ADDENDUM NO. 1

PROJECT NAME: NEBRASKA SOCCER & TENNIS COMPLEX - SOCCER FIELD
UNL PROJECT NUMBER: C909P101
BID INVITATION NUMBER: 2268-13-7200

CONSULTANT: OLSSON ASSOCIATES, INC.
ADDRESS: 1111 LINCOLN MALL, SUITE 111, LINCOLN, NE 68508

DATE OF ISSUANCE: WEDNESDAY, NOVEMBER 20, 2013
DATE OF BID OPENING: TUESDAY, NOVEMBER 26, 2013

REVISED DRAINAGE PLAN

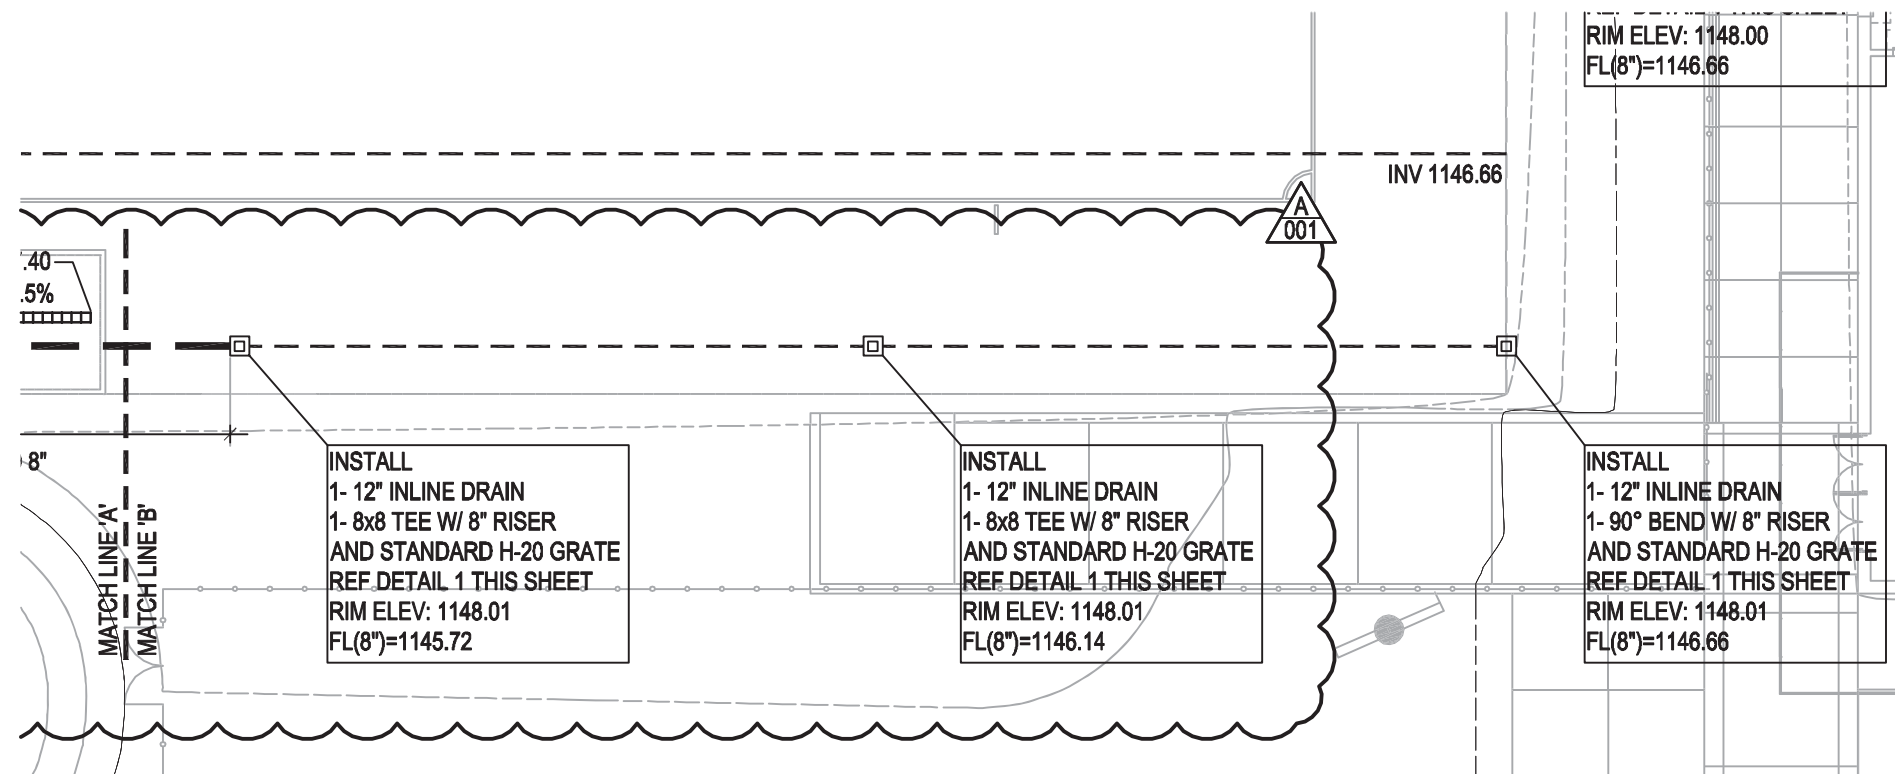
1. Refer to Drawing No. SDL04 for revisions to the subdrainage pipe for the synthetic turf area

REVISED PLANTING PLAN

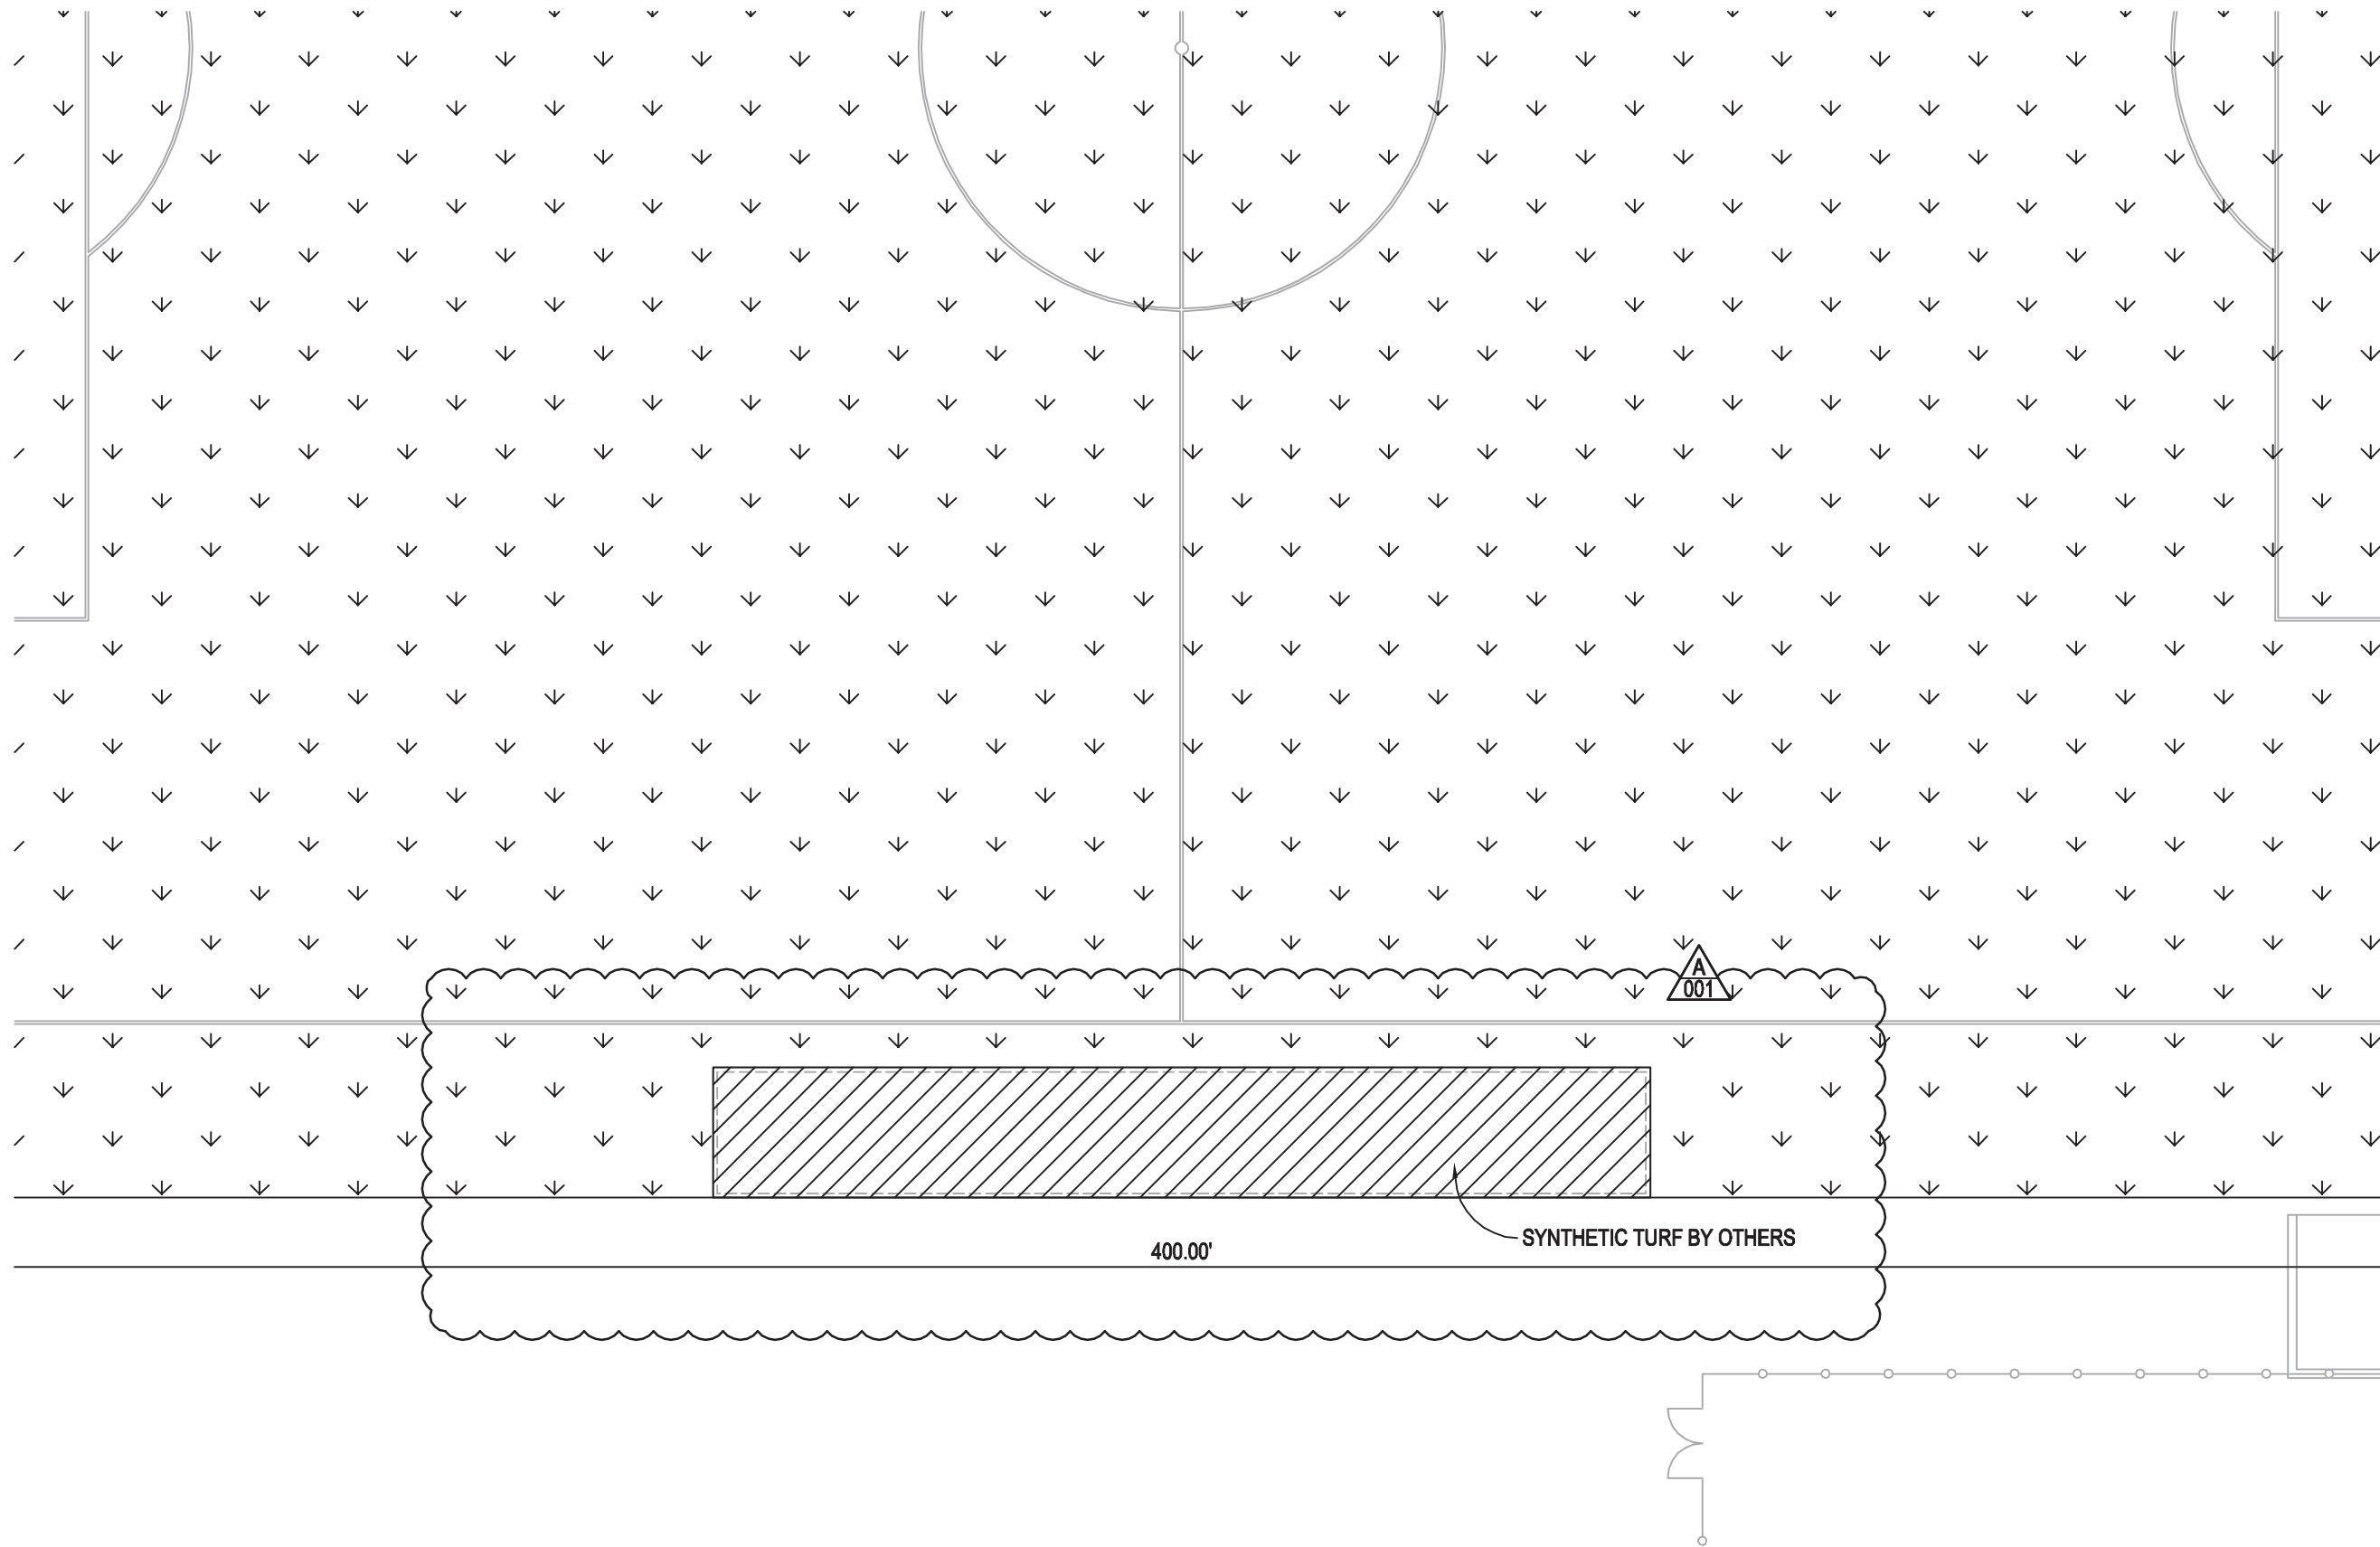
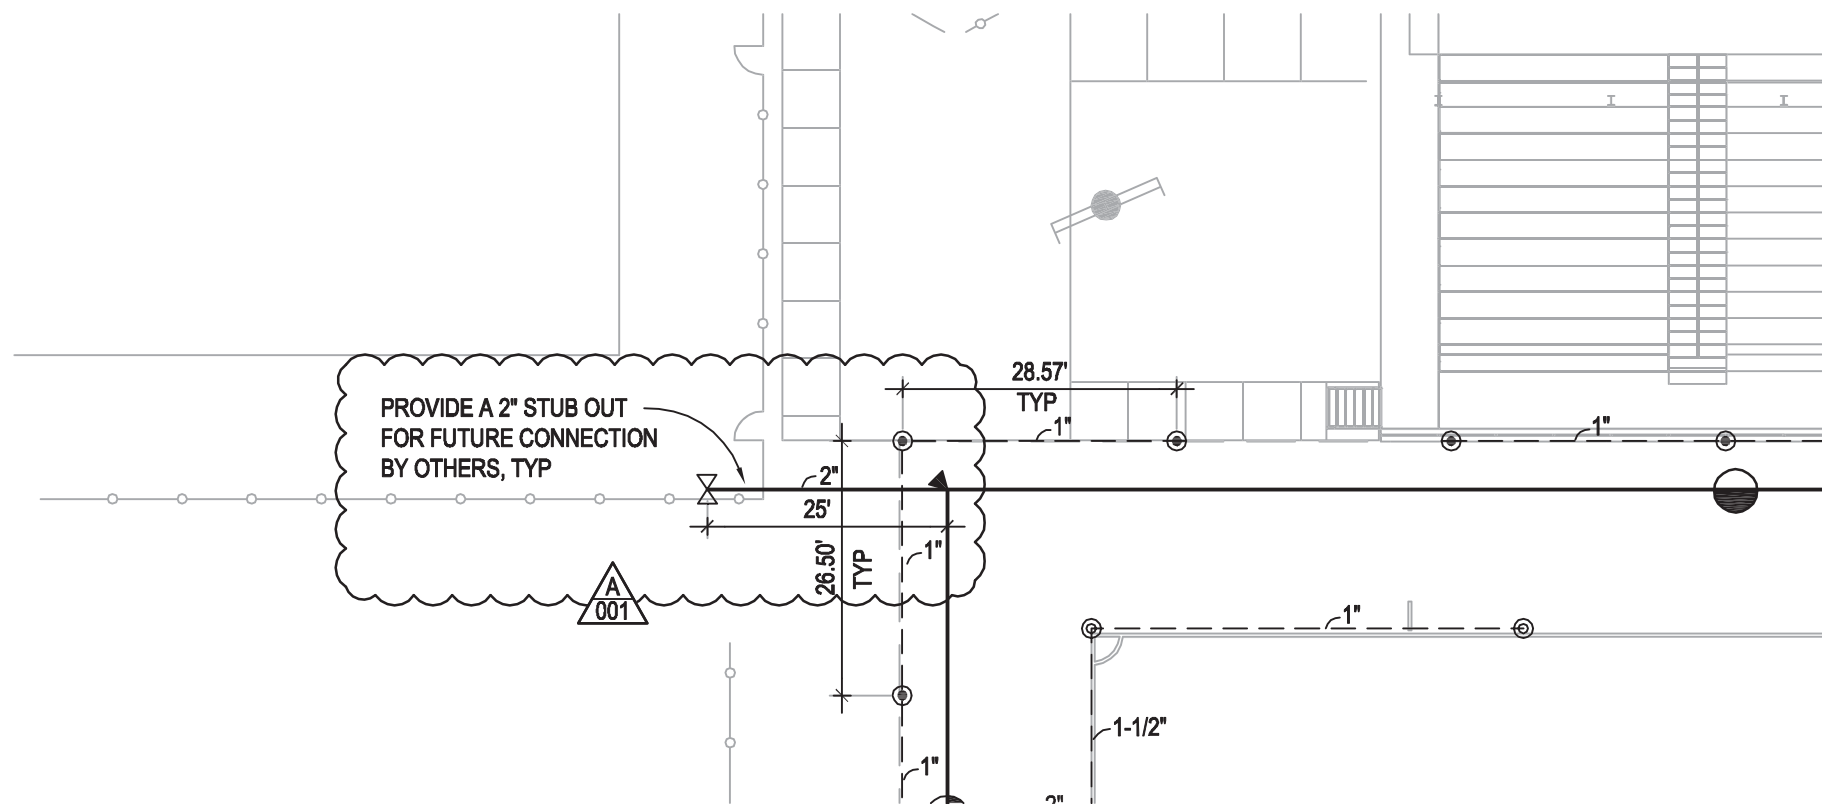
1. Refer to Drawing No. SDL05 for revisions to the sod areas around the synthetic turf area

REVISED IRRIGATION PLAN

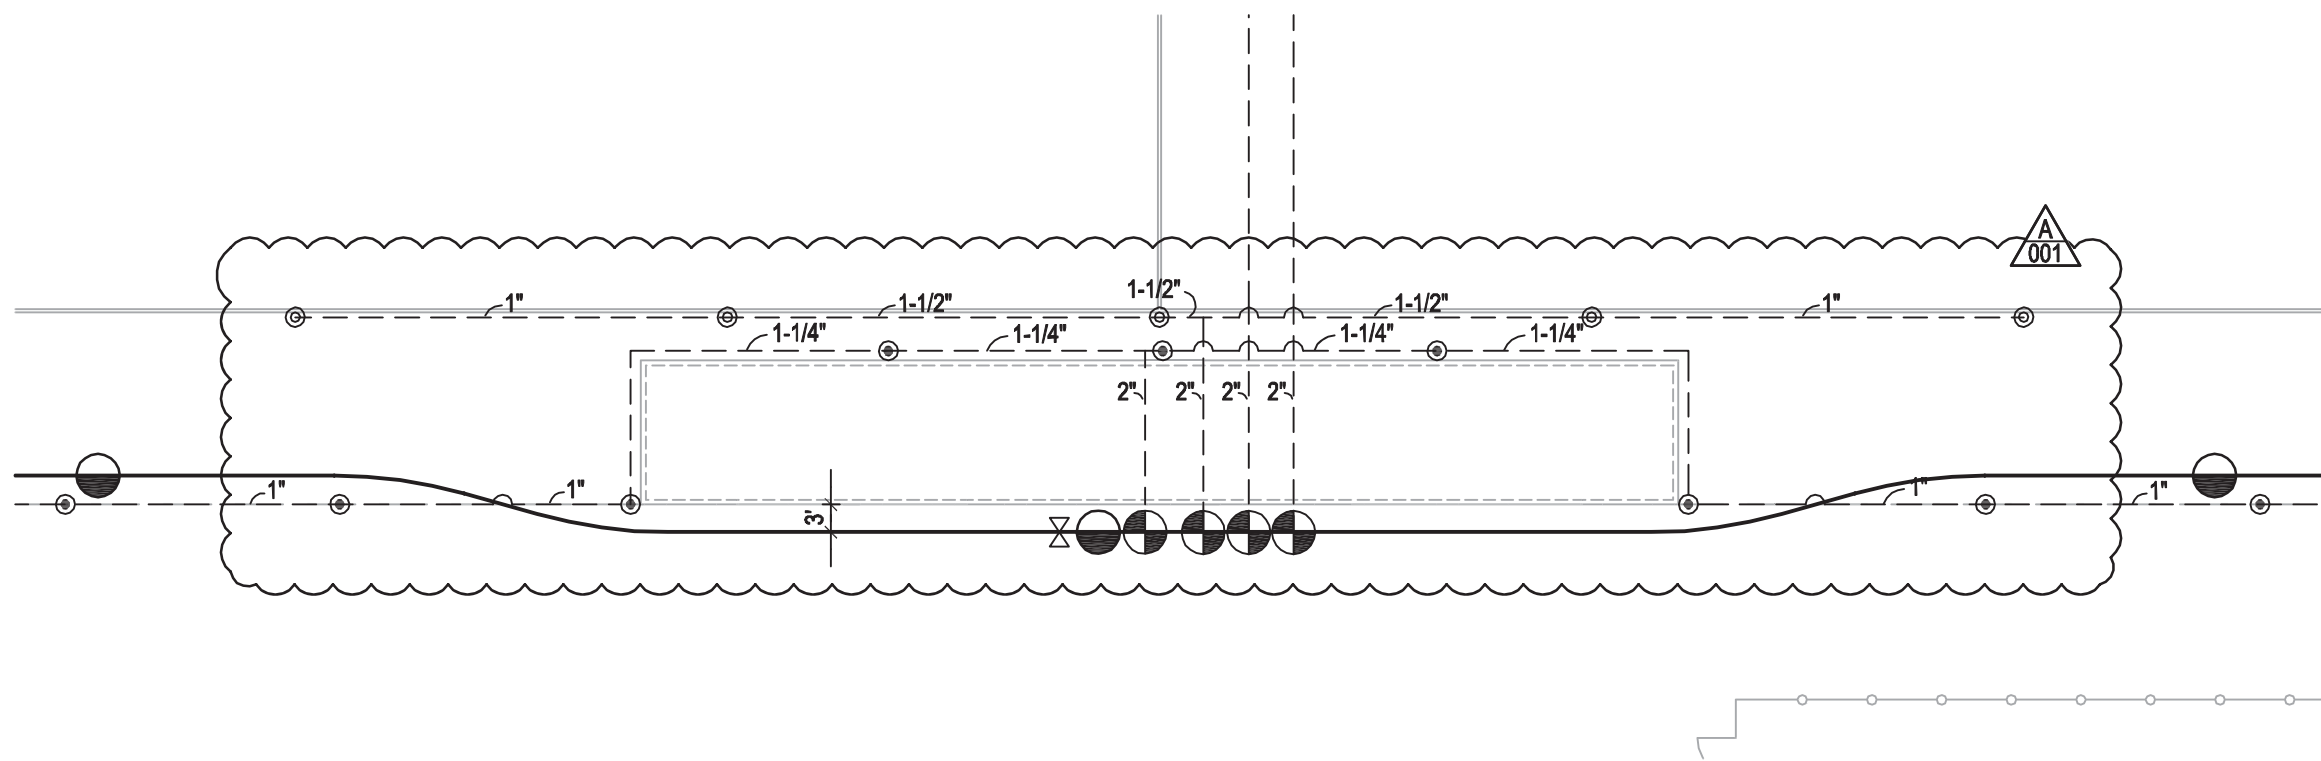
1. Refer to Drawing No. SDL06 for revisions to the irrigation system around the synthetic turf area
